1 **Appendix C: Use of NSM as targets for System-wide**
2 **Performance Measures**

29 **2.0 Comparison of NSM Sens4 to Historical Information by**
30 **RECOVER Members**

28 **Figure 27. Comparison of Simulated and Historically Estimated Seasonal**
29 **Amplitude in Water Depths for 29 Ridge and Slough Landscape Indicator**
30 **Regions**

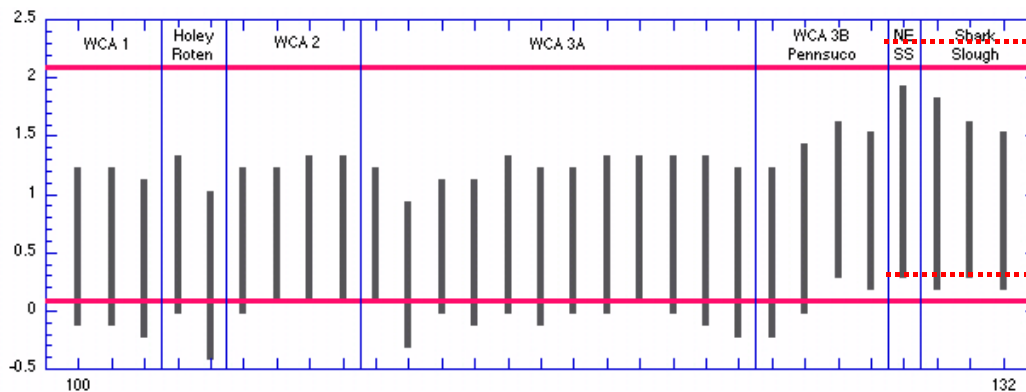
11
12 McVoy did find, however, that model-simulated water depths for both NSMv.4.6.2 and
13 Sens4 were “substantially shallower” than pre-drainage water depths estimated from
14 historic observations. The shortfall in depths simulated was stronger in the wet season (-
15 0.9 feet), compared to the dry season (-0.15 feet). Comparison of simulated (NSM
16 Sens4) and historically estimated seasonal amplitude in water depths for 29 ridge and
17 slough landscape IRs showed that simulated minima are similar to historical
18 observations, but simulated maxima and seasonal amplitude are much lower than
19 historical observations. He concluded that the shortfall is significant and would
20 substantially reduce simulated flows. The similarity of simulated water depths in NSMv.
21 4.6.2 and NSM Sens4 suggests that the shortfall is due not to the difference in topography
22 between the two runs, but to other (unidentified) model inputs. McVoy recommended

23 that further sensitivity analysis of the model be conducted and cautioned model users to
24 recognize that both NSMv.4.6.2 and NSM Sens4 substantially underestimate pre-
25 drainage water depths and, as a result, very likely underestimate flows as well.
